Accessibility Survey

City of Downey Ryerson Avenue - De Palma Street To Adwen Street

Date of Inspection
4/20/2017

Disability Access Consultants

Bush South Of Benares Street @ 33.944255558170, -118.156192749739

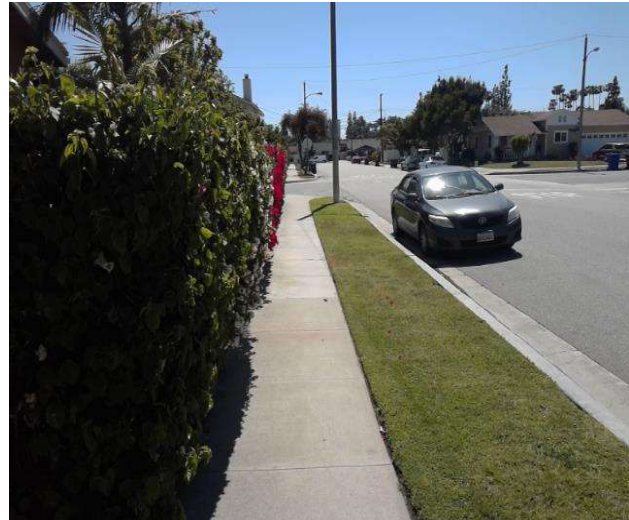
Sidewalks , Hazards & Gratings : Sidewalk Width at Obstruction

Sidewalk width at the obstruction is not compliant.

On-Site Finding 32.00 inches

Sidewalk width at the obstruction shall have the recommended value.

Recommendation At least 48.00 inches
